Arbor Heights

Arbor Heights
4220 SW 100th Street
SDCI #:3025192

Design Recommendation

2018.04.03

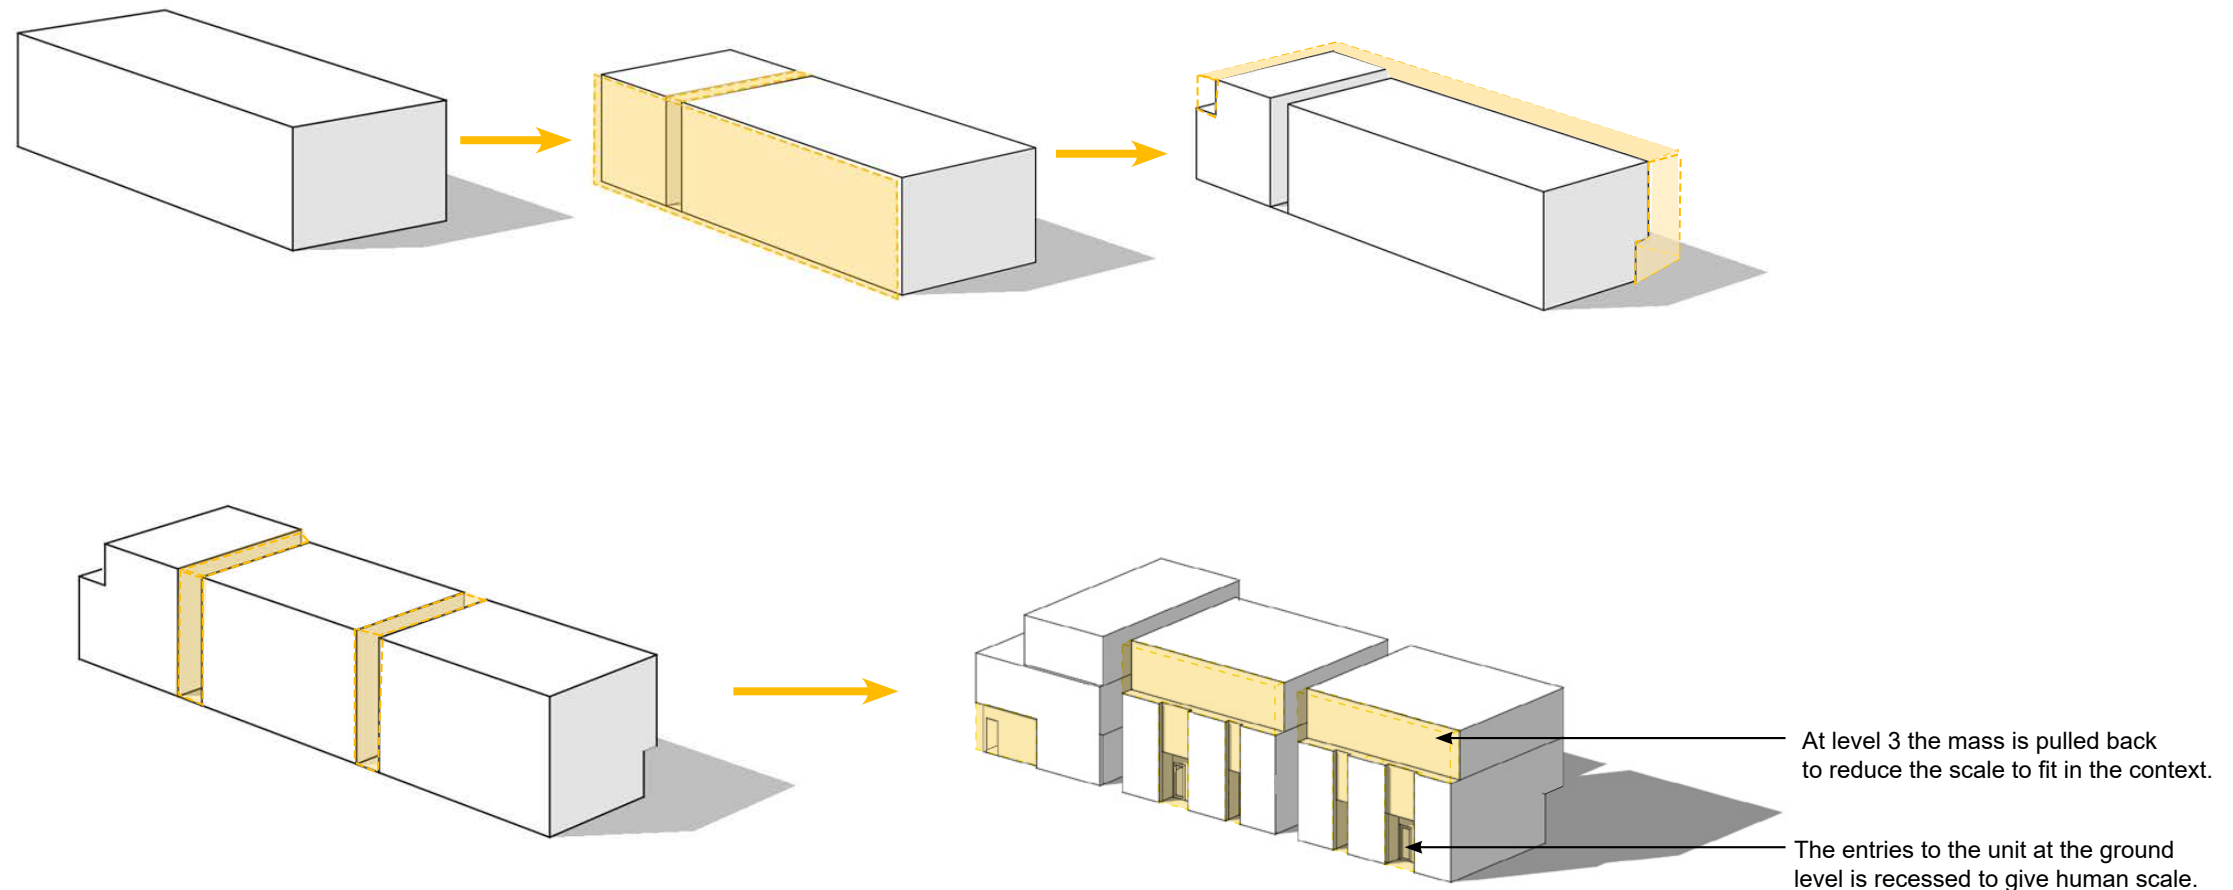
A.i The design concept should be further reduced from two masses to three distinct masses as contemplated in Scheme 2 that harken to the existing pattern and scale of the immediate context of single family-zoned properties.

A.i Approved Scheme 3 has been developed further and has been reduced from two mass to three mass as a response to the existing character of the single-family neighborhood. The developed masses fits well within the existing rhythm and urban pattern. The building is set away from the north property lot to create a buffer from the single-family residence and maintain privacy for the neighboring units. To maintain the scale on the California Ave SW street, the west building mass at level 3 is stepped back to create a transition from the multi-family residential zone to single-family zone. The penthouses of the east units facing SW 100th St are removed to reduce the scale of the building.

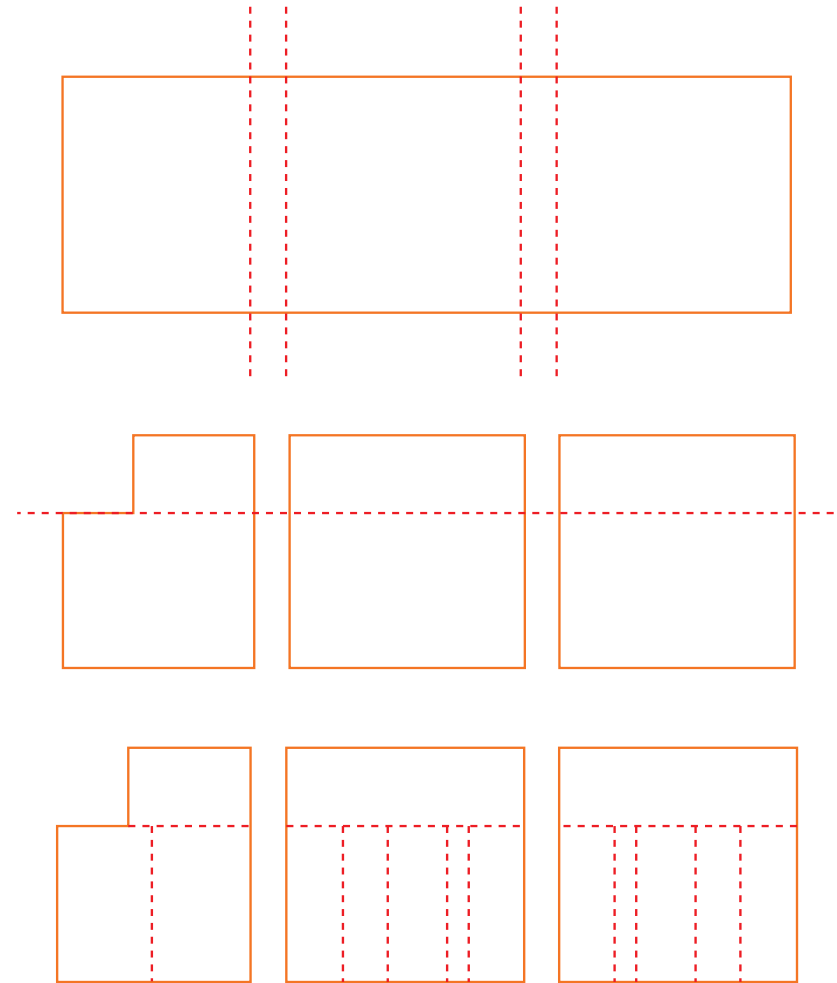
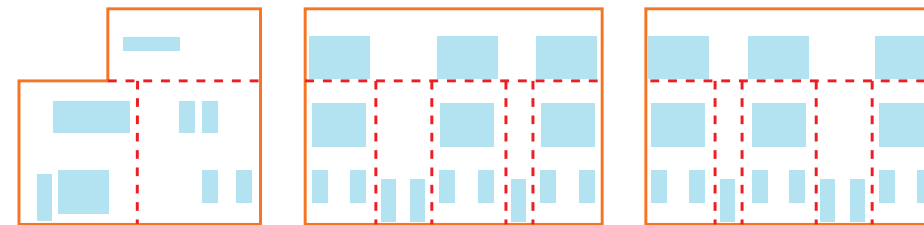
A.ii A. II. It is imperative that each building mass be scaled down appropriately to better respond to the surrounding residential context. The Board looks forward to reviewing the next design iteration which should be comprised of secondary architectural elements, minor massing moves, materials, glazing, etc. That successfully achieve this design direction. Initial Board feedback concerning the conceptual perspective illustrated in the design packet (pg. 47) was that the amount of glazing applied to the buildings' exterior facades was an inappropriate response to this guidance.

A.ii The facade is further broken down using well-composed openings and balconies. Facades are modulated through the use of high-quality, durable materials. Materials help enhance the simple massing forms and overall architectural character within the neighborhood. At street level, the human scale is achieved by using recessed doorways, steel canopies, and large windows. This helps to maintain the interaction with the street.

Facade Broken into 3 units vertically to fit in the context of single family neighborhood

Horizontally broken to match the human scale. Level 3 is terraced back to match the scale on the street.

Each facade and entrance is further divided to resemble the neighborhood scale.

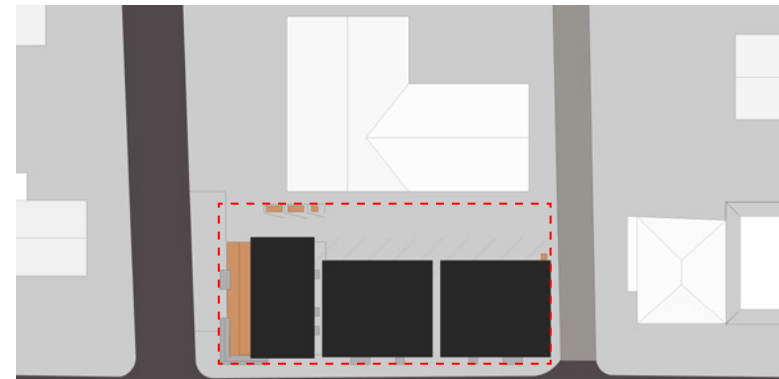
B The Board acknowledged that, in response to public comments voiced at the first EDG meeting, the design proposal had evolved from a commercial use (nine live-work units) to now a mixed-use proposal with both commercial (one live-work unit) and residential uses (eight townhouse units). The Board voiced concern that differentiating the sole live-work unit from the surrounding townhouse units may be difficult. The Board voiced a willingness to support a design that includes additional live-work units that, if pursued by the design team, be arranged in the western building mass with corner frontage to accommodate live-work units with internal programming to allow viable commercial spaces.

C The Board recognized that the removal of the “towering” stair penthouses was effective in reducing the perceived height of the massing and encouraged this design modification be carried through to the next design iteration.

D The Board requested that in addition to building materials, color palette, conceptual lighting and signage designs; specifics concerning waste storage, location, access, and feedback from SDCI and Seattle Public Utilities (SPU) should be presented to the Board at the next meeting.

B The corner portion of the site is designed as a live-work unit to maximize the visibility. The facade is designed with maximum transparency to accommodate the commercial use. The glazing for the live work unit is at much higher percentage compared to the other townhouse units. This maintains the eye on the street and activates the corner.

C The building mass is set away from the north property line, to maintain the privacy of the single-family house adjacent on the north side. The Building program is designed to achieve a gradual transition from single family to a multifamily residence and then to commercial part of the site. The height along the street is reduced by setting the upper level back from the facade.

D The waste storage area and its size, coordinated and approved by SPU, is located along the north property line next to the drive aisle away from pedestrian circulation. The waste storage area is screened with clear sealed cedar slats.

Without Departures

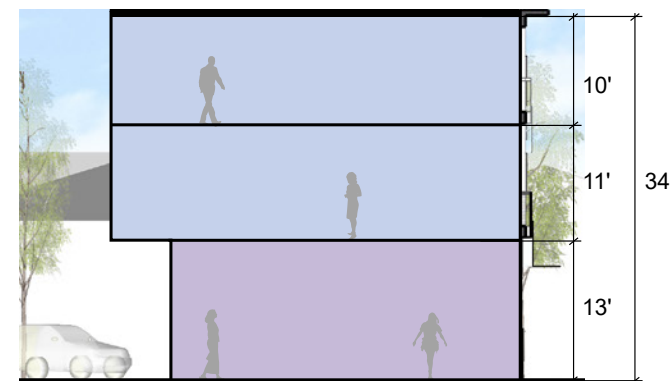
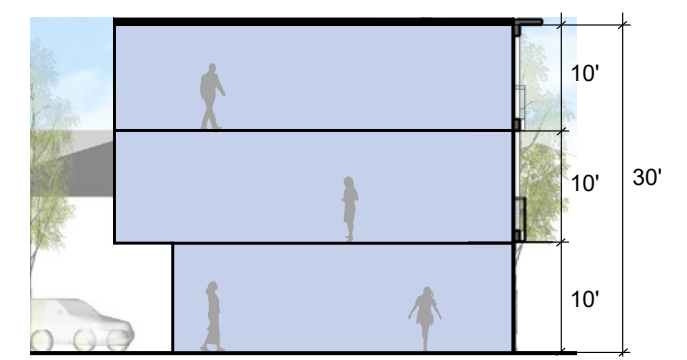
#	Departure Request	Code Requirements	Explanation for Departure
1	Departure requested for curb cut exit on California Ave SW for 1-way drive aisle vehicle exit.	SMC 23.47A.032.A21: Access to parking shall be from the alley if the lot abuts an alley improved to the standards of subsection 23.53.030.C, or if the Director determines that alley access is feasible and desirable to mitigate parking access impacts. If alley access is infeasible, the Director may allow street access.	Proposed 1-way drive aisle vehicle exit on California Ave SW allows for 30'-6" depth for six units and 32'-5" depth for three units and meets the requirement for at least 30'-0" depth for commercial spaces on the ground level. Vehicles enter via the alley and exit through the proposed curb cut exit on California Ave SW, providing a generous radius for vehicles to turn. This supports 8 parking stalls for the project.
2	Departure requested for units with residential uses that occupy more than 20% of the street-level street-facing facade.	SMC 23.47A.005.C1: Residential uses at street level in NC and C zones may occupy no more than 20 percent of the street-level street-facing facade.	In respect to the site's surrounding residential context, the project is proposing eight townhouse units and one live-work unit. This reduces the amount of proposed commercial activity. This also eliminates commercial design standards which require extra height.

3	Departure requested for the floors of the dwelling units along California Ave SW and SW 100th St at less than required minimum of 4 feet above/below sidewalk grade.	SMC 23.47A.008.D2: The floor of a dwelling unit located along the street-level street-facing facade shall be at least 4 feet above or 4 feet below sidewalk grade or be set back at least 10 feet from the sidewalk.	To keep the residential character of the surrounding context, the street-level floors of the units are placed at less than required minimum of 4 feet above/below sidewalk grade for both California Ave SW and SW 100th St. This allows for a reduced height for the project. If now allowed, a viable townhouse configuration cannot be achieved.
4	Departure requested to allow reduced floor to floor height for L-W unit to match TH heights at L1.	SMC 23.47A.008.B4: Height provisions for new structures or new additions to existing structures. Non-residential uses at street-level shall have a floor to floor height of at least 13 feet.	This allows for a reduced ceiling height at the L-W L1, allowing the unit with reduced overall height.

5	Departure requested to allow small parking spaces (7.5' x 15') for the proposed project.	23.54.030.B1.B: When more than five parking spaces are provided, a minimum of 60 percent of the parking spaces shall be striped for medium vehicles. The minimum size for a medium parking space shall also be the maximum size. Forty percent of the parking spaces may be striped for any size, provided that when parking spaces are striped for large vehicles, the minimum required aisle width shall be as shown for medium vehicles.	Small parking spaces shrink the depth of the parking area to provide more parking stalls for future residents and allow for the appropriate backup distance. Smaller parking stalls also allow for a waste staging area along the alley.

According to SDOT, this new curb alignment will not eliminate parking. SDOT cannot guarantee future curbside parking, but for now and near future SDOT does not see any reason to restrict curb side parking on this site.
